From: Graham, Laura 
Sent: 19 June 2017 18:06
To: Michael Eastham
Cc: Claire Potts
Subject: FW: Fitzalan Link - LU.234.16.RES

Subject: RE: Fitzalan Link - LU.234.16.RES

Following review of the submission, WSCC comments as follows:

Cycleway Connection to Highdown Drive.

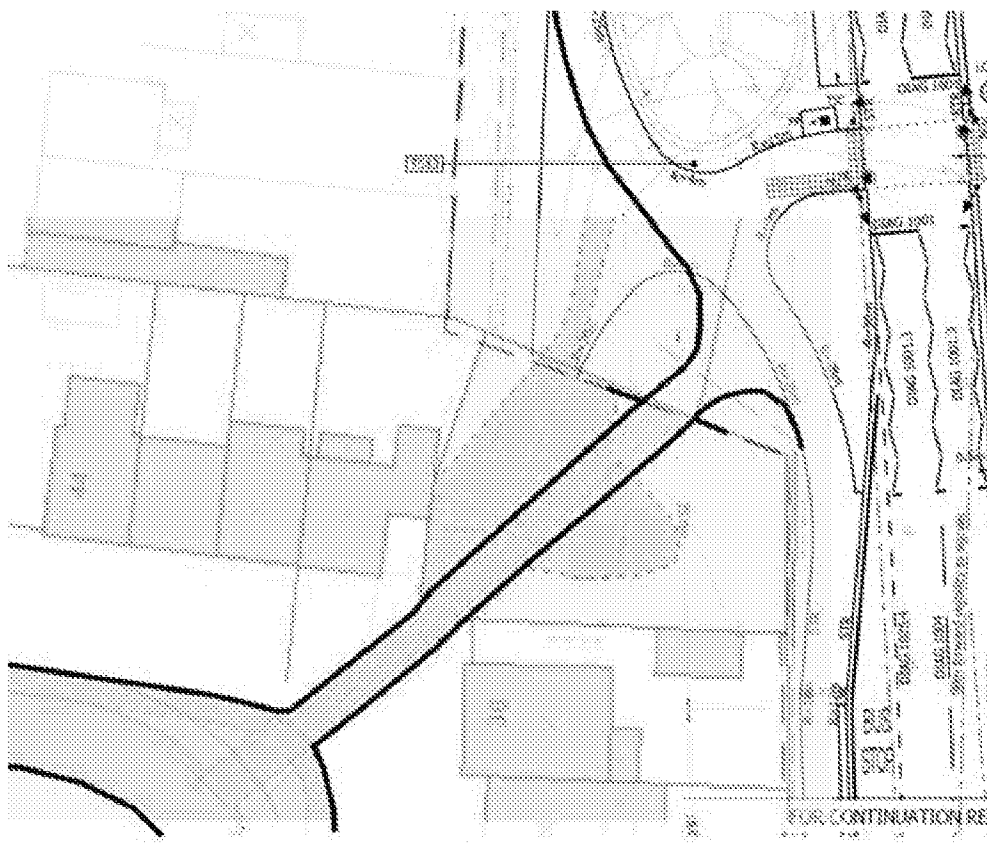
You have again offered an explanation for the path alignment in the vicinity of the Toucan crossing and balancing pond. The radii proposed are acceptable to us but the path must connect properly to the path leading to Highdown Drive which should be upgraded to a shared footway-cycleway. I have indicated below what this might look like. However, looking at this again shows the pink area to be public highway and on the line of part of Public Footpath 3103. Therefore, it is recommended (and indeed appears more straightforward) to retain this line otherwise it appears that any continuation of the route south of your scheme might cross land that might not be highway. Any path should be lit, edged, resurfaced, signed and tactile-paved appropriately although these final details can be shown at the S38/278 stage. Any upgrade from Public Footpath to shared footpath-cycleway must be undertaken in-accordance with WSCC PRow procedures.

The highway boundary plan and alignment of the existing PROW is noted. However, this is not evident on the ground since the Academy has been constructed (see extract from Google Earth below). We can show the alignment requested, (based on the OS Highway Boundary plans provided) but we would only have the power to construct the pathway up to our limit of ownership (the red line). WSCC has less than Freehold rights beyond the red dashed line and as such we don't believe we would have any power to undertake works on this area of land (see attached) to effect the PROW route beyond the red line, hence the reason for showing the tie-in (at the limit of ownership) to the existing physical route present on the ground. Therefore, we believe that what we have shown on the submitted drawings is the best solution, unless WSCC can confirm that we could legally obtain power to undertake works on land that they don't have complete freehold rights over.
